# CITY OF ALBUQUERQUE

**RE: Marie Hughes Elementary School**  
**5701 Mojave St NW**  
**Request for Temporary C. O. – Accepted**  
**Engineers Stamp Date 9/30/15 (D11D007)**  
**Certification dated: 12-13-16**

RE: **Marie Hughes Elementary School – 2701 Mojave Street, NW**  
**Grading and Drainage Plan for Building Permit**  
**Engineer's Stamp Date 9-3-2015 (D11D007)**

**RE: Marie Hughes Elementary School – 2701 Mojave Street, NW  
Grading and Drainage Plan for Building Permit  
Engineer's Stamp Date 7-31-2015 (D11D007)**

SUB-BASIN #	AREA (AC)	LAND USE (AC)			Q (CFS)
		B	C	D	
A	2.28	0.37	0.63	1.28	8.1
B	2.54	0.52	1.34	0.68	7.7
C	3.17	0.68	1.67	0.82	9.7
D	1.90	0.23	0.39	1.28	7.1

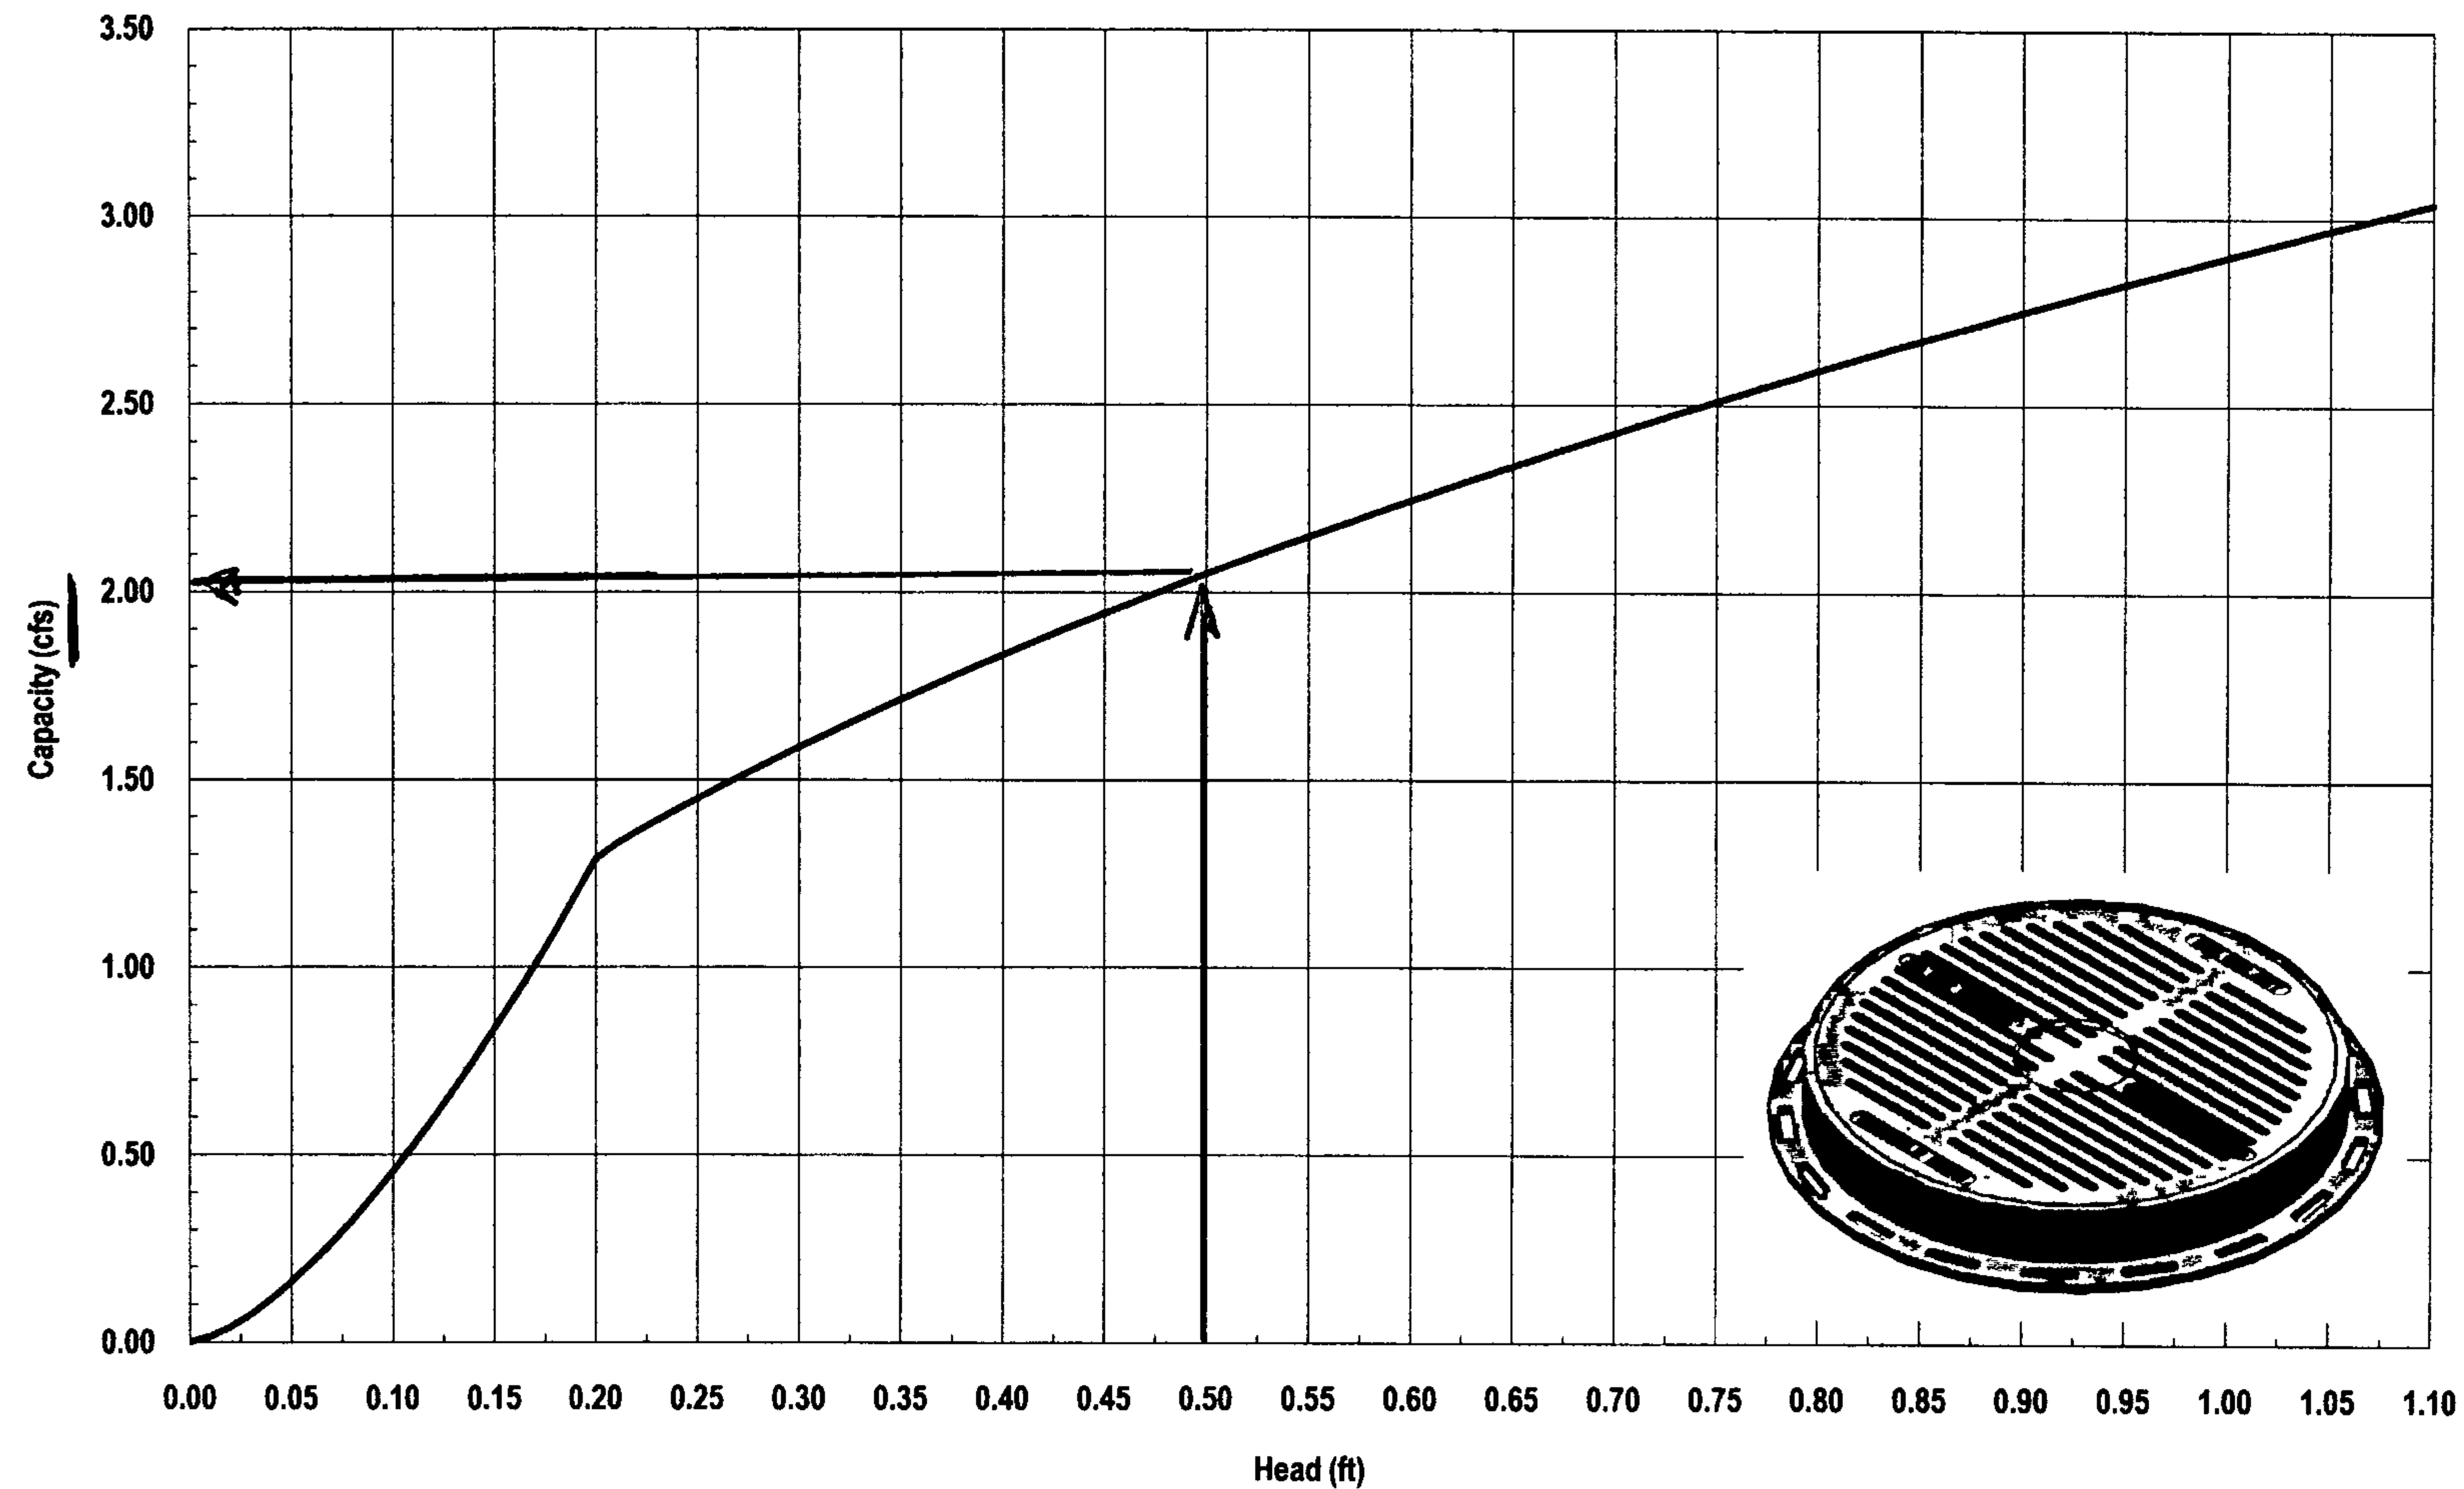
3. Analysis Points:
  - a. Provide calculations for inlet and culvert capacities shown on table in "Notes"
  - b. The 4 Analysis Points add to 6.8cfs, but the total is 32.7 cfs. Provide an onsite basin map showing the contributing flows from each basin.

- c. Show amount of flow at all discharge points – into streets, ponds, inlets, etc.
  - d. Basin Map should show how much flow is going in private storm drain system. Provide capacity calculations for the private Storm Drain.

- 3a. See inlet and culvert capacity calculations on attached sheet.  
b. The 2<sup>nd</sup> column gives basin area (in acres), which I suspect you added to arrive at 6.8? The next to last column gives flow rate values in CFS.

c. Discharge point flow rates have been added.  
d. Sub-basins have been defined on the plan and storm drain calculations are shown on the attached calculation sheet.

Nyloplast 18" Pedestrian Grate Inlet Capacity Chart

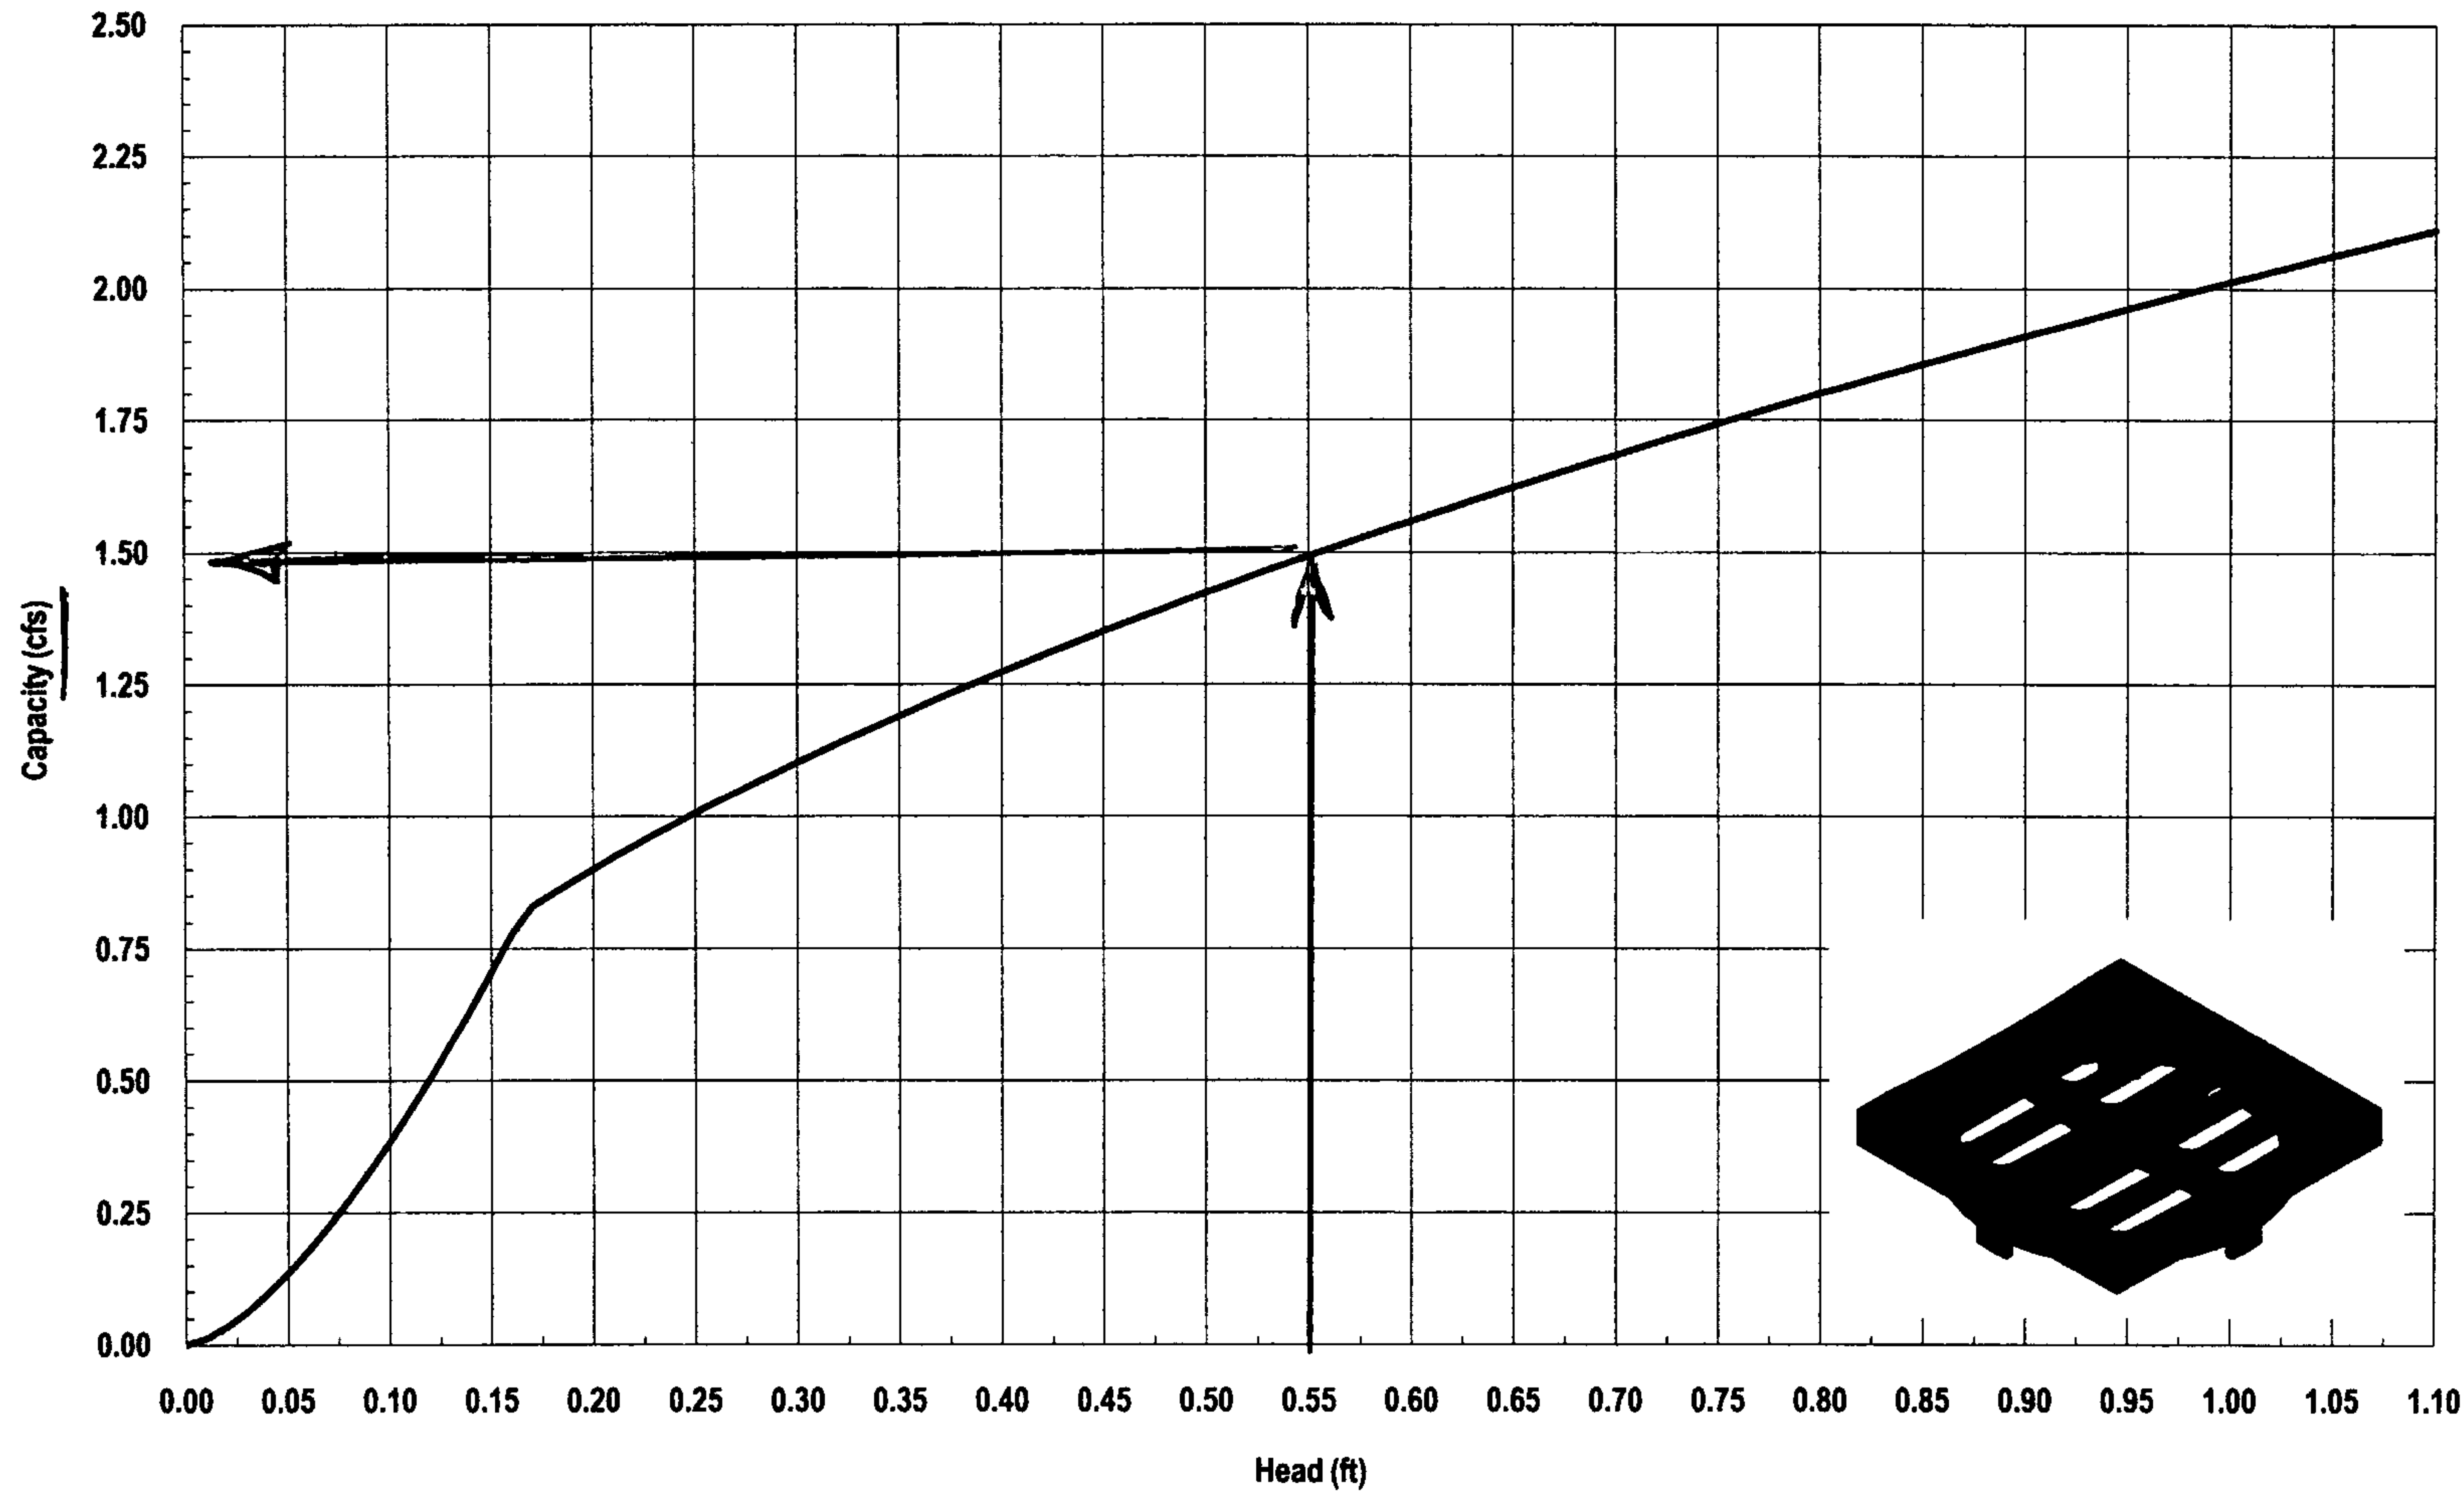
- ✓c. Show that the inlets can collect flows from the street and this development without flooding.
  - ✓d. Are inlets in a sump? Contour information is cut off.

Courtyard inlet capacities (per attached Nyloplast Charts) are 3-18" inlets at 2.0 CFS and a 12" inlet at 1.5 CFS for a total of ~~7.5 CFS~~. There is an overflow provided at the SW corner of the courtyard area where excess flow can be conveyed on the surface to the drop off lane and on to Mojave NW. A roof area of approximately 12,000 SF will discharge 1.2 CFS below grade directly to the western drain basin.

3 INLETS @ 2.0 CFS = 6.0 CFS
